Architectural Review and Historic Preservation Board Agenda Report

File: AR 17-37

RE: Nine Star Cedar Street Apartments, 1005 W. 6th Street; APN 004-206-005
New multi-family housing development

DATE: APRIL 2016
 SCALE:
 DRAWN:
 JOB: 17-2296
 SHEET: ARB-1

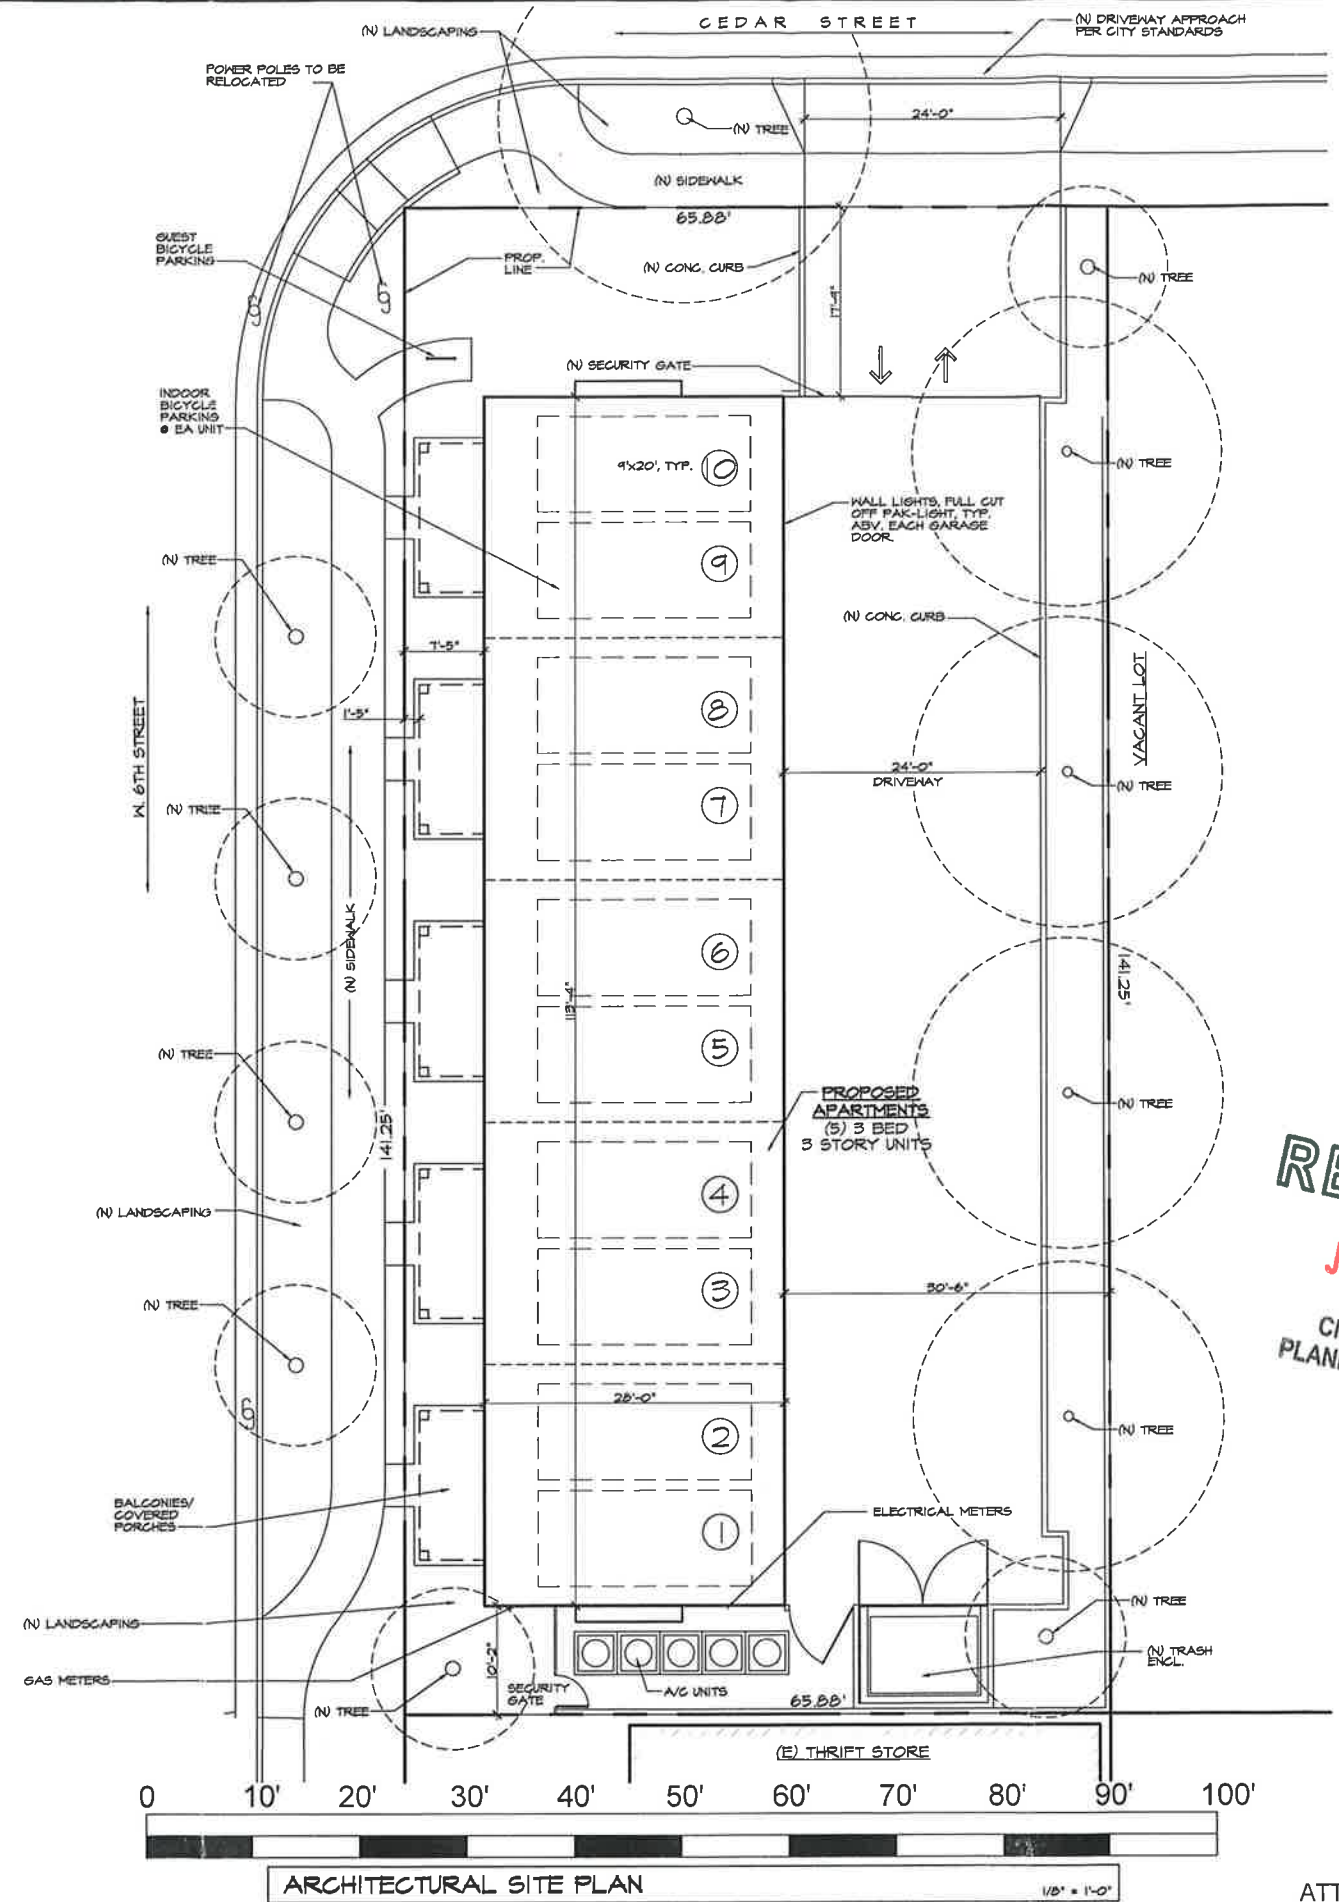
The proposal includes a new three-story building oriented to front W. 6th Street with tuck-under parking, parking lot shade trees, trash enclosure and surrounding landscaping (see **Attachment B**, Overall Site Plan and **Attachment C**, Project Description). The site is currently developed with a single-family home that has been converted to office space that will be demolished. The proposed site plan illustrates the front of the building placed close to W. 6th Street, with sidewalk leading to each of the unit's front doors. Each unit would feature a second story porch balcony and a two-car garage located on the first floor.

The parking area is located to the side of the buildings, providing vehicle visibility to residents while reducing views of automobiles from the public street (DGs 1.1.14, 4.1.52, and 4.1.53).

Reduction of a single guest parking space is proposed pursuant to Chico Municipal Code (CMC) section 19.70.050.A (see **Attachment I**, Parking Reduction Request). A reduction in off-street parking may be approved by the Board subject to making certain additional findings as outlined below. The project includes ten off-street parking spaces and the code typically requires one guest parking space for every five residential units. In this case, staff supports the slight reduction of off-street parking based on the site's proximity to CSUC and anticipated student tenant population. On-street parking supplies are not overburdened in the immediate area, and the site is served by a bus transit route (Route 9). The project includes private, secure bicycle parking to encourage alternate means of transportation. The additional findings required to approve a reduction in off-street parking are provided below.

ATTACHMENT ' E '

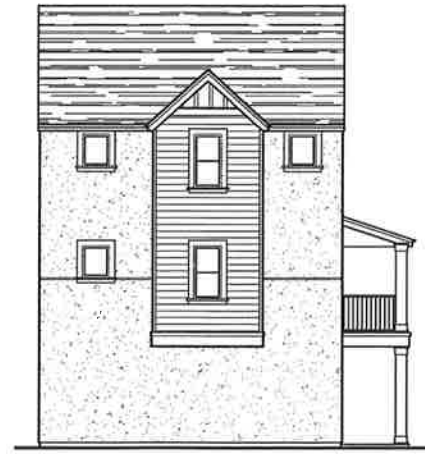
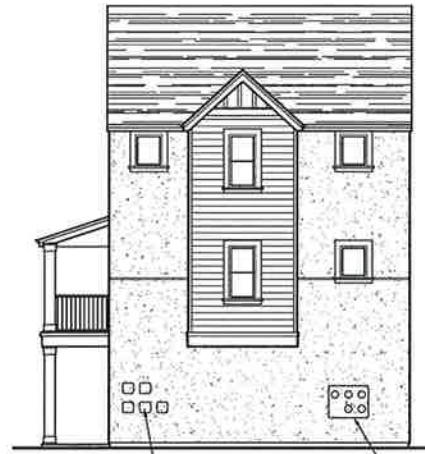
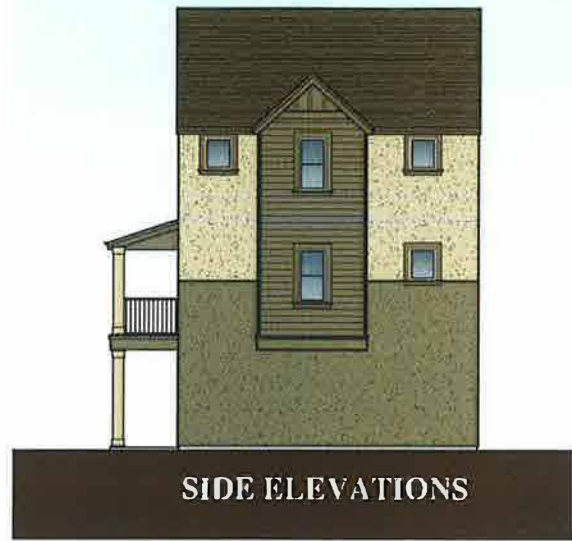
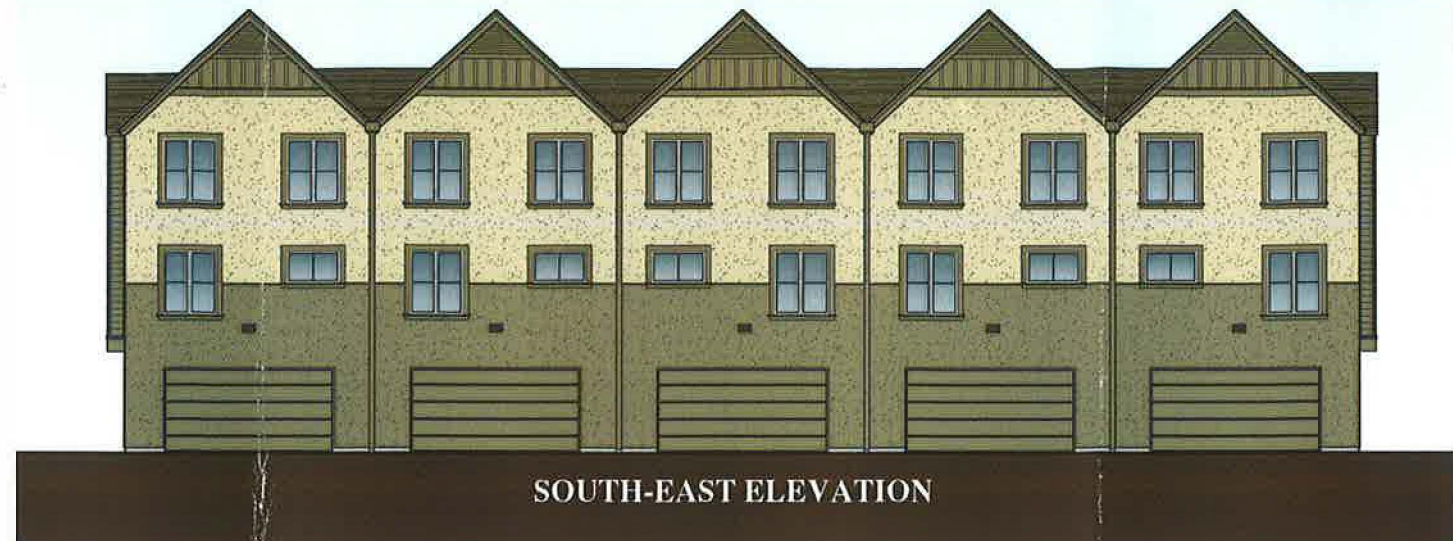
The building's exterior would feature stucco surfaces with sand finish. The top half of the building would be beige (Kelly Moore "Greystone") and the bottom half would be medium grey (Benjamin Moore "Sparrow") (see **Attachment D**, Color Board). The front and rear elevations feature a saw tooth roofline with composite shingles, accented with board and batten siding in grey. The southeast and northwest elevations feature a cantilevered mass with lap siding in grey, and gable roof to match the front and rear rooflines. Shed roofs, supported by vernacular-style wood columns, cover second floor balconies on the front (northwest) elevation. The balconies, supported by the same style columns, create covered entry porches below, six feet in depth. Decorative wall pack lights are proposed over each

garage door and can-lights are proposed in the ceilings of the front porches (see **Attachment E**, Elevations and **Attachment F**, Lighting Specifications). Wide window trims featured on all windows would be painted grey. A concrete masonry trash enclosure with grey stucco finish and ribbed metal doors is proposed at the southwest corner of the site.

The proposal efficiently utilizes the site by arranging the building in a vertical fashion, placing required parking inside ground-level garages and living spaces above. A pedestrian-friendly streetscape is emphasized by use of balconies and covered entry porches along the front elevation. Cantilevered masses on the north and south elevations reduce a flat appearance, as do the balconies and front porches along the front elevation.

The project is consistent with several General Plan goals and policies, including those that encourage compatible infill development (LU-1, LU-4, and CD-5) and providing adequate supply of rental housing to meet a wide range of renters and future needs throughout the city (H.3, H.3.2, and H.3.4). The placement of the building on the site is consistent with policies that encourage orientating multi-family housing developments and front entries to the street (DG 4.1.13 and 4.1.35). Ground-floor entries and second-story porches help to define the individual dwelling units (DG 4.2.11, 4.2.13, and 4.2.41). The saw-tooth roof style creates an interesting roof line while avoiding monotony (DG 4.1.15).

PRELIMINARY LANDSCAPE PLAN

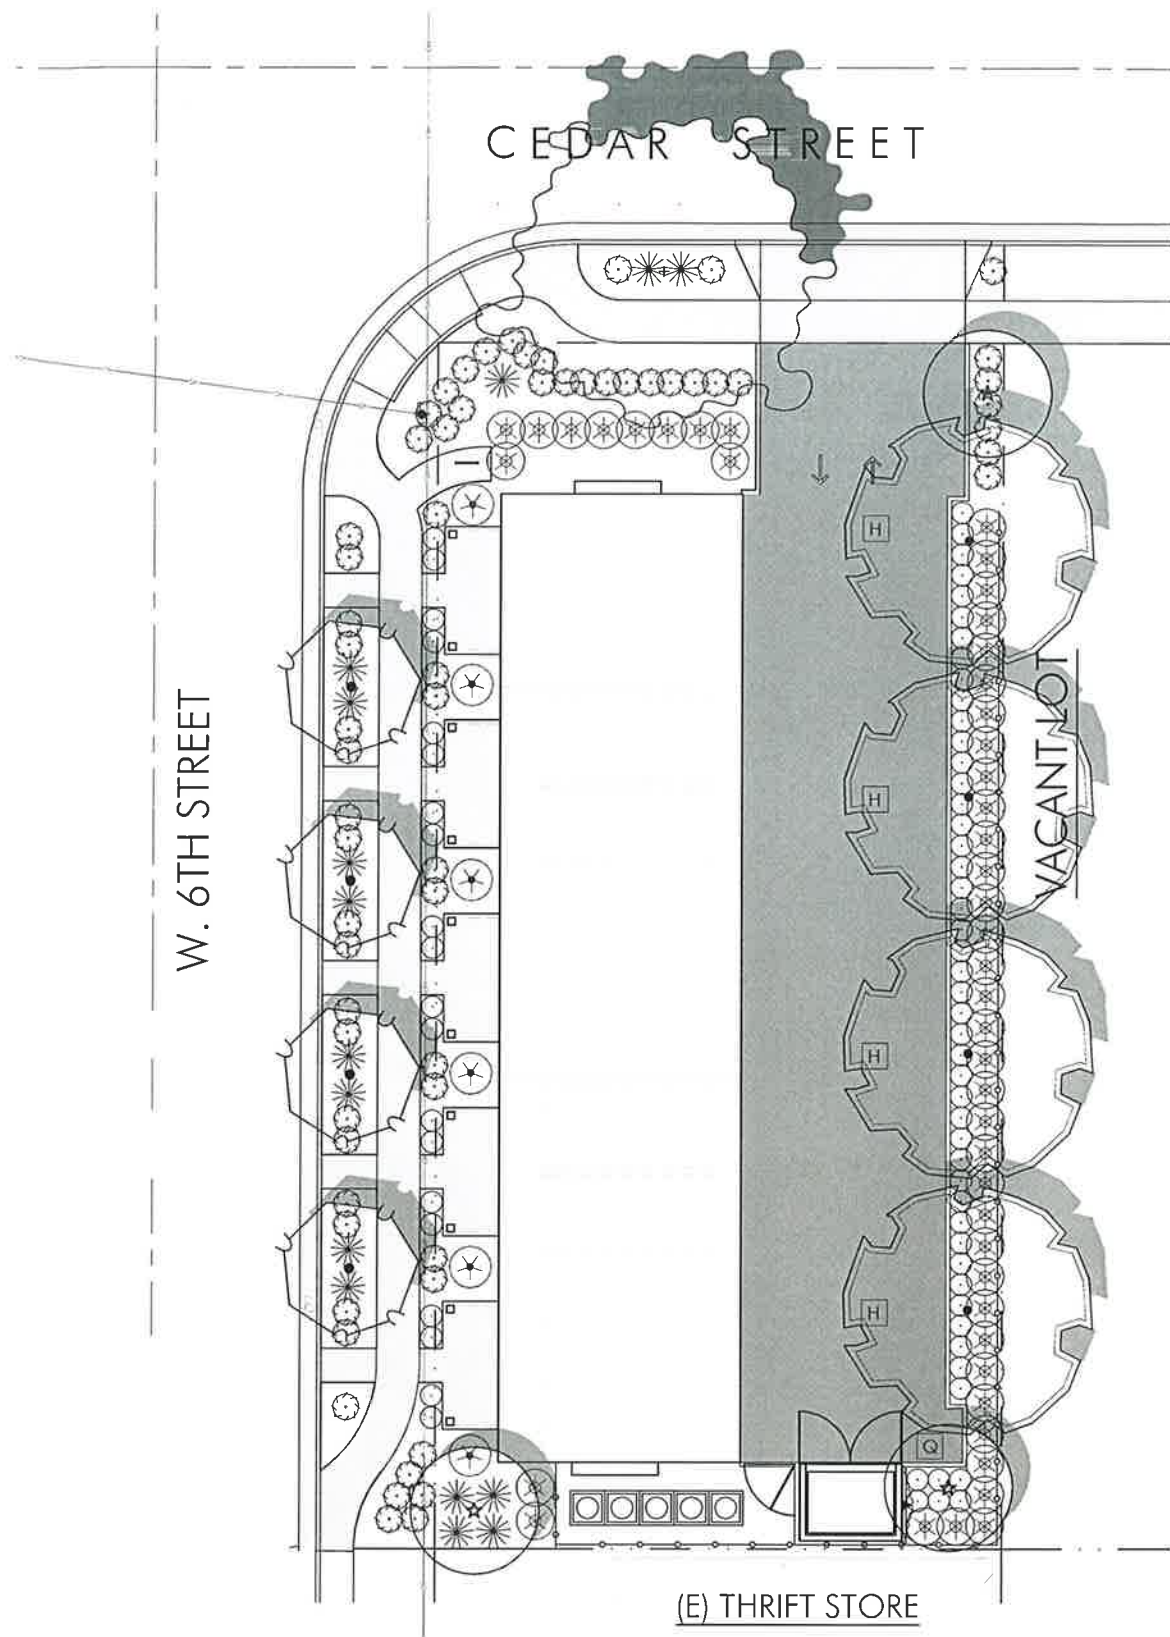
New landscaping is proposed around the perimeter of the site that includes accent trees (crepe myrtle and rocky mountain glow maple), shrubs and vines. Four autumn purple ash trees would provide parking lot shading that is estimated to reach 53 percent at tree maturity (see **Attachment G**, Landscape Plans). A single California black oak is proposed within the park-strip along Cedar Street. A 6-foot high cedar fence would be located along the west and southwest property lines. The landscaping plan indicates five ailanthus trees to be removed from the site.

The proposed landscaping will provide visual relief around the site perimeter, softening the building's proximity to West 6th Street, and will provide adequate parking lot shading. Tree and plant species have been thoughtfully and appropriately selected for their locations and the variety of plant types will provide color, texture and coverage to the overall project.
